Comhairle Chontae Atha Cliath Theas

Record of Executive Business and Chief Executive's Order

Reg. Reference: SD22A/0357

Proposed Development:

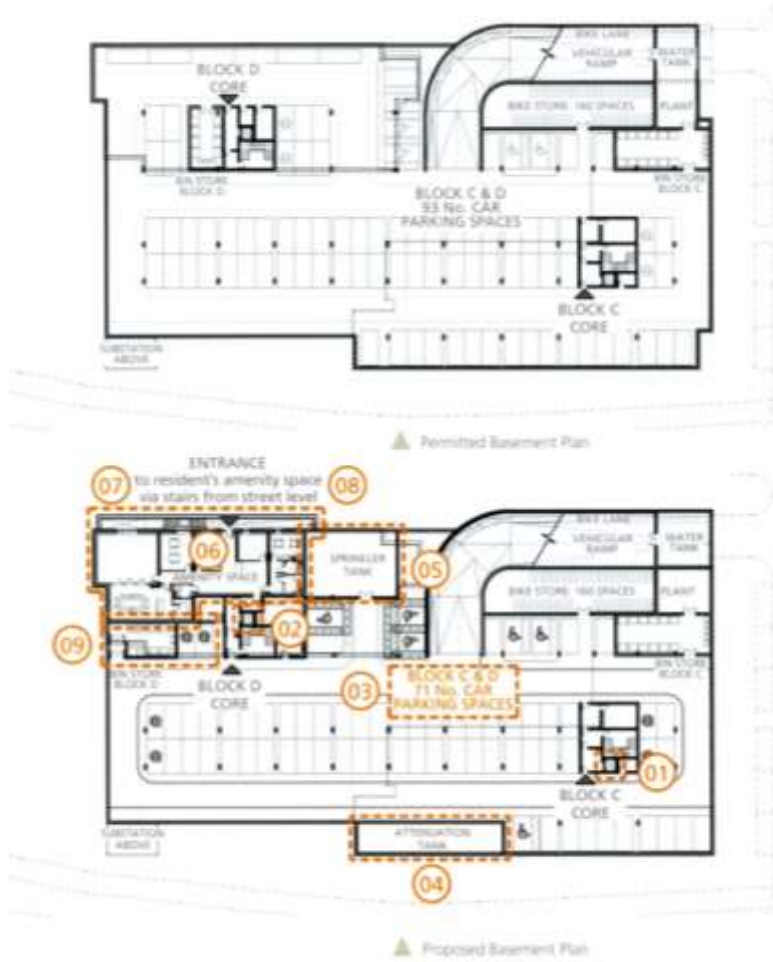
Amendments to the permitted car parking areas at basement levels

The proposed development consists of amendments to the permitted car parking areas at basement levels resulting in a total **loss of 29 car parking spaces** (151 car parking spaces are provided in total at basement level). SHD ABP. Ref. 308088-20 originally permitted 180 car parking spaces at basement level and 11 spaces at surface level. This element of the proposal considered to be acceptable and is discussed further in the Access & Parking section of the report.

Block D East Elevation Changes

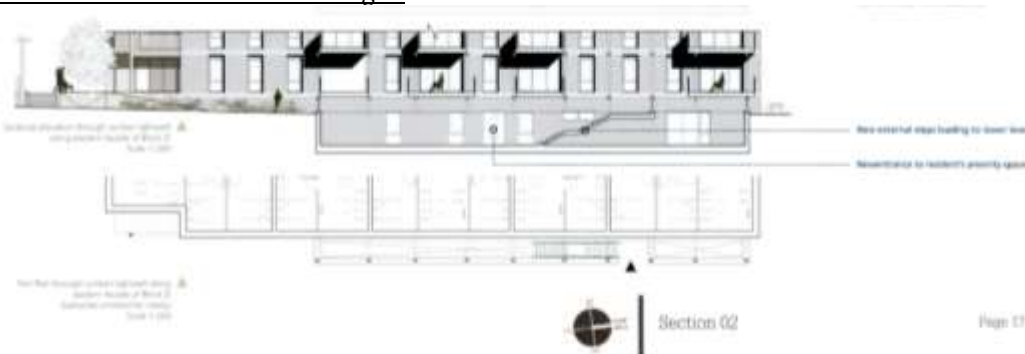
Minor elevation amendments to permitted Block D

The proposal seeks minor elevation amendments to permitted Block D comprising of a new external stair well to the eastern elevation of Block D providing access from the ground floor level to the basement level. Access to amenity space will be provided by lift and stairs through Block D and by external stair access from street level and also via direct access from the basement car park. This amendment to the proposed SHD is considered to be acceptable.
